TOO'GHA INC. – TANANA, ALASKA

WATER DISTRIBUTION & WASTEWATER COLLECTION SYSTEM

ISSUED FOR CONSTRUCTION

RECORD DRAWING CERTIFICATE

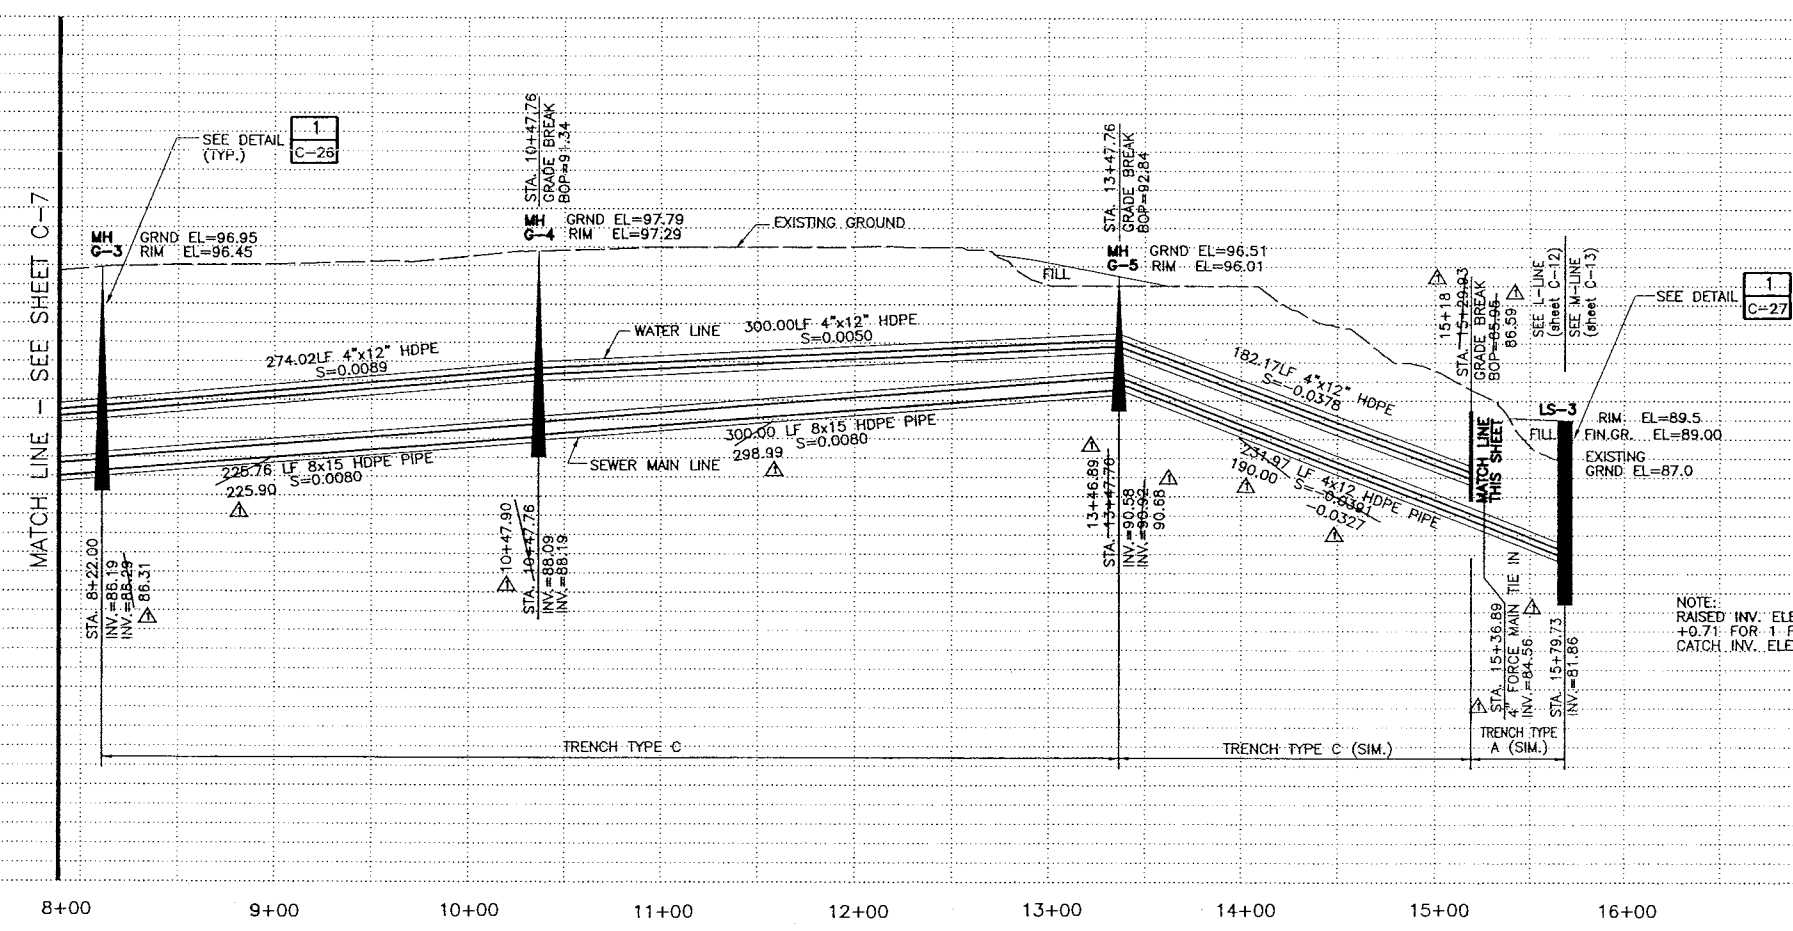
NOTE:
RAISED INV. ELEV. STA. 15+18 TO 15+30
+0.71' FOR 1' FT. MINIMUM FILL OVER SEWER.
CATCH INV. ELEV. STA. 15+40 INV. 85.32

TOUGH INC. - TANANA, ALASKA
WATER DISTRIBUTION &
WASTEWATER COLLECTION SYSTEM
L - LINE SEWER AND WATER
PLAN AND PROFILE

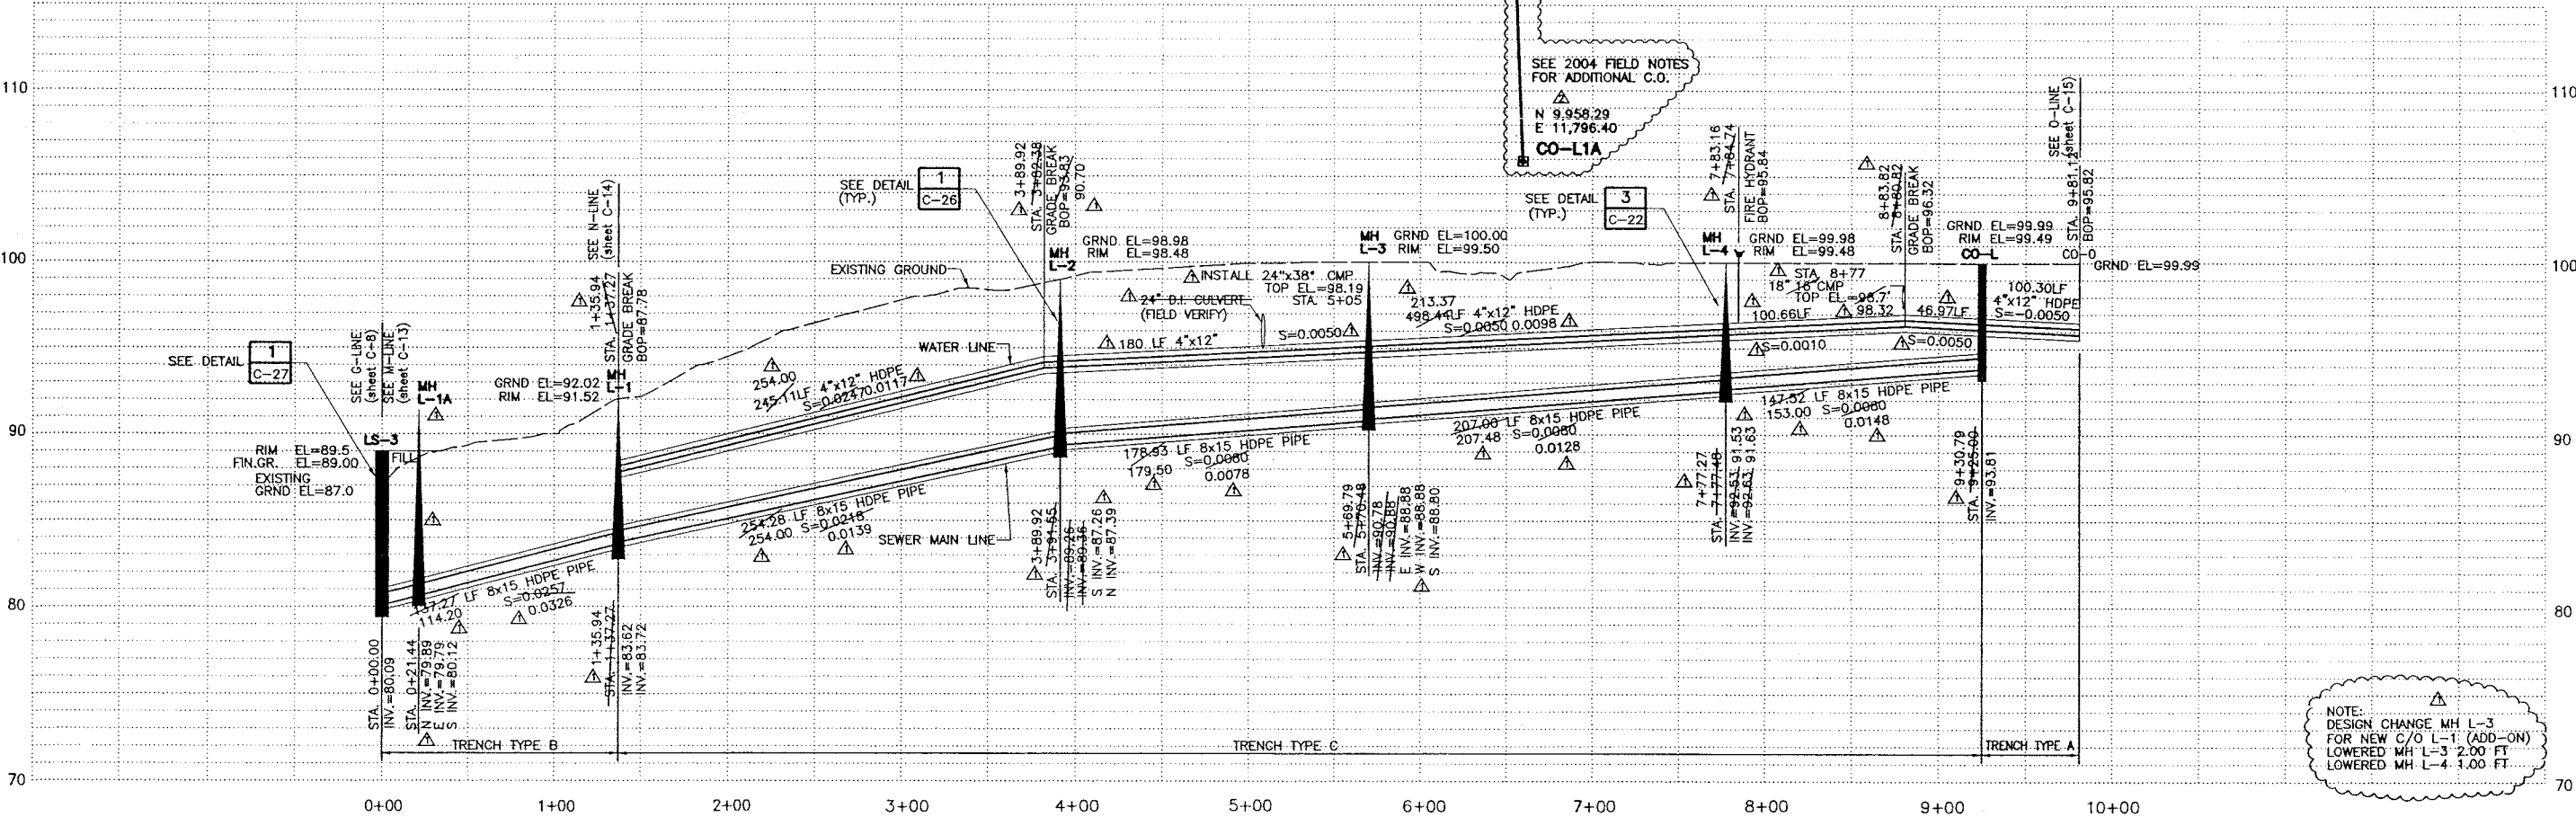
NOTE:
DESIGN CHANGE MH L-3
FOR NEW C/O L-1 (ADD-ON)
LOWERED MH L-3 2.00 FT
LOWERED MH L-4 1.00 FT
